SERVICE BULLETIN

NUMBER: DCI-BH407-IBF-SB02
Date: 12 July 2021

SUBJECT: BACKSHELL FASTENER REPLACEMENT

Bell Helicopter - Model: 407 (STC SR09368RC) (SN 0001 & SUBSQ)

Figure 1 – Location of Backshell Screws Recommended for Replacement

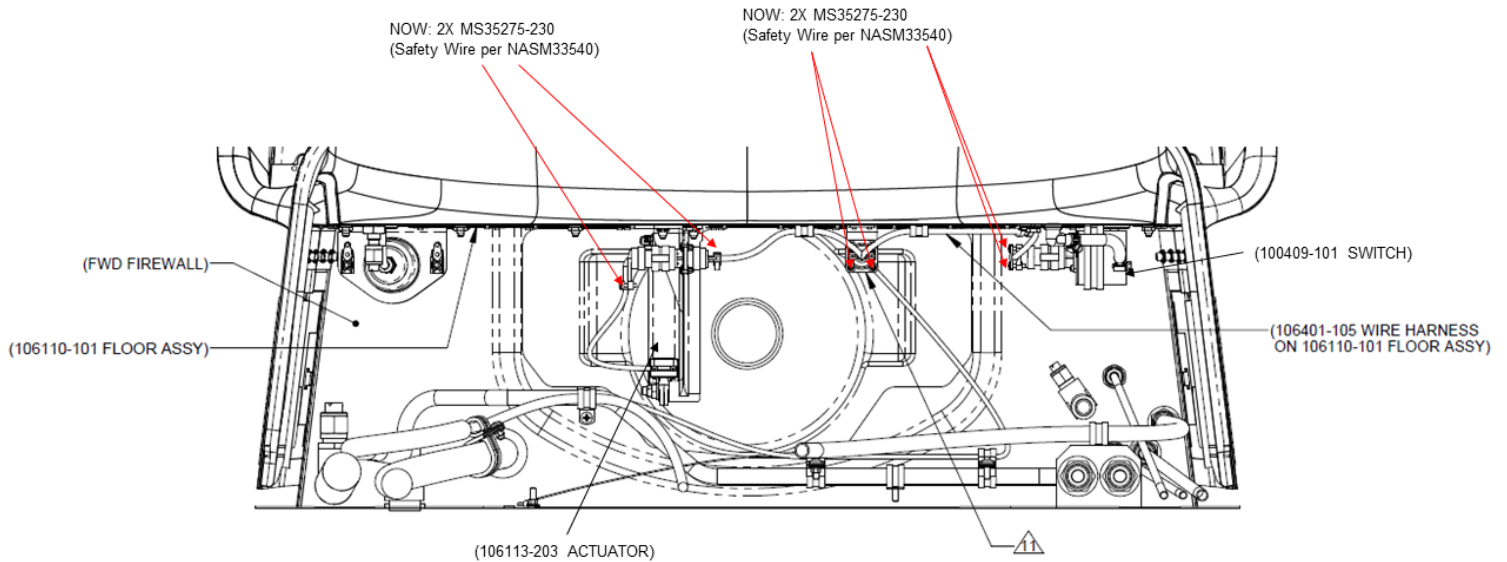
This is not a safety of flight issue, if operators follow Section 8.5.5 of the Instructions for Continued Airworthiness (ICA) and verify that Backshells are secure during regular maintenance intervals, then it is highly unlikely that the Backshell fasteners will come loose during flight. Nonetheless, Donaldson recommends a product improvement for all operators of the DCI Bell 407 IBF by replacing the existing fasteners on the Backshell of the 106401-105 Wire Harness connecting to the linear actuator & the Backshell of the linear actuator (106113-203) with MS35275-230 screws and to safety wire the screws per NASM33540. Location of these screws can be found depicted in Figure 1. Inspection requirements for the Backshells will remain the same unless otherwise directed by a newer revision of the ICA (Reference 1).

Operators are recommended to locally procure the replacement hardware as applicable. If local procurement is not available, operators can procure the screws from Donaldson's ecommerce site found in the Contact section.
